**Proposed Changes to
Final 2018 Integrated Energy Policy Report Update, Volume II**

**For Consideration at the February 20, 2019
California Energy Commission Business Meeting**

Page numbers refer to the report posted on January 28, 2019, that does not show changes in underline-strikeout (docket number 18-IEPR-01, TN# 226392). Added text is shown in underline; ~~deleted text shown in strikeout~~.

Table 10: Utility-Scale Generation Additions in California ~~Since July 1, 2017~~ From July 2017 Through December 2018

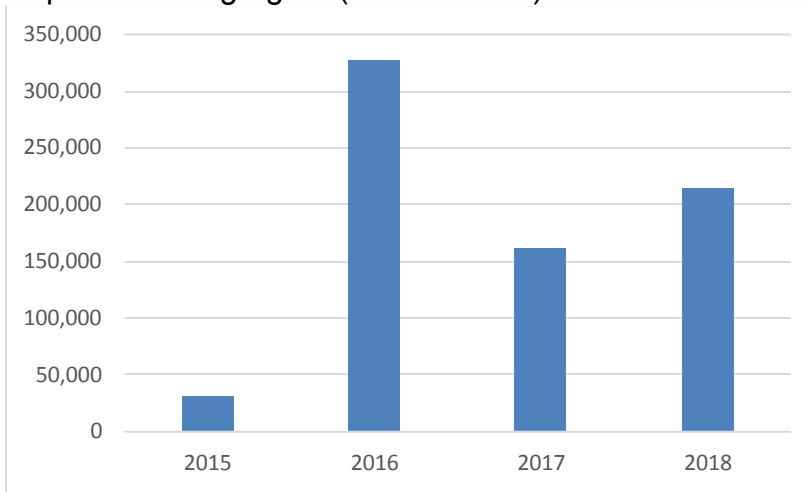
California continues to add utility-scale generation, almost all of which is renewable. As shown in Table 10, ~~31 of the 40~~ 59 of the 73 projects added since July 1, 2017 through December 2018, are solar photovoltaic (~~928 MW~~ 1,339 MW), with ~~only two~~ three of them combusting natural gas (~~32~~ 557 MW).

Replace existing table and title (shown below)

With this table and title (shown below)

Technology	< 20 MW		≥ 20 MW		Total	
	Number	MW	Number	MW	Number	MW
Solar	36	107	23	1232	59	1,339
Wind	3	5	3	306	6	311
Biofuel	3	3	2	55	5	58
Natural Gas	1	4	2	553	3	557
Total	43	119	30	2146	73	2,265

Chapter 3, page 93, Figure 14, Annual Avoided Renewable Curtailment due to Western EIM (MWh):

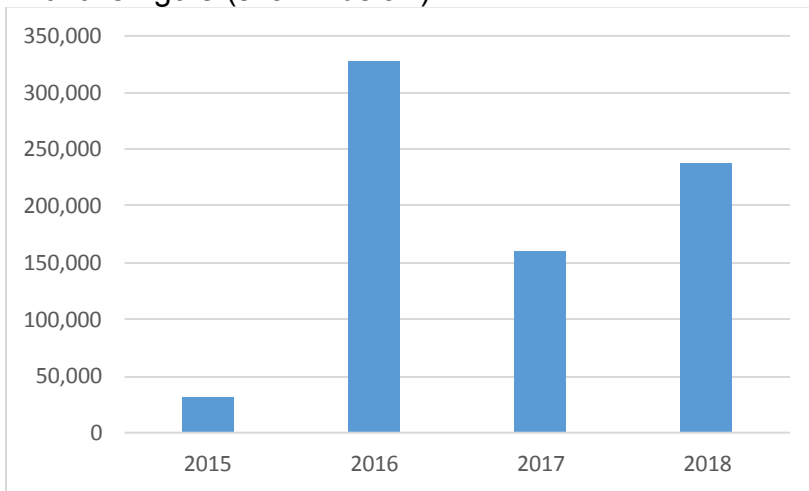
Replace existing figure (shown below)

Reductions in renewable curtailment in ~~the first three quarters of 2018~~ exceeded those for ~~all of 2017~~; total reductions through ~~December 31~~September 30, 2018, since 2015 exceed ~~734,000~~757,000 MWh. Associated reductions in GHG emissions are more than ~~314,000~~324,000 metric tons CO₂e.

With this figure (shown below)

Figure XX: Southern California Gas System Outages

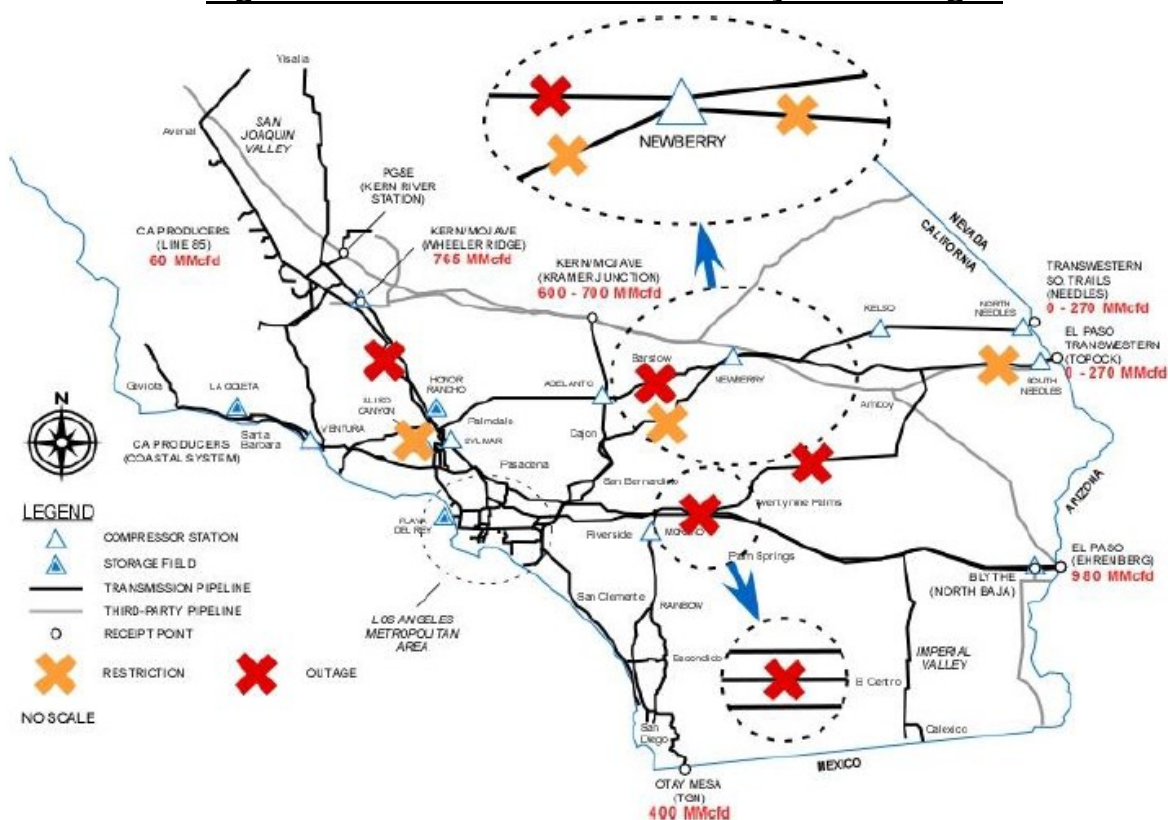
Winter 2018–2019 marks the third winter that the joint agency technical assessment group released a winter assessment (*2018–2019 Winter Assessment*).⁴²⁷ Southern California continues to face reliability challenges to its energy system in winter 2018–2019, primarily due to continuing outages and reduced capacity on key natural gas pipelines. The current operating status of the SoCalGas system is mostly unchanged from last winter, as described in the section “Current Operating Status of the SoCalGas System,” except for the extra gas stored at Aliso Canyon and Line 3000, which returned to service September 17, 2018, at reduced operating pressure, in theory allowing receipts from the Topock area. (See Figure XX.)

New Figure (shown below)
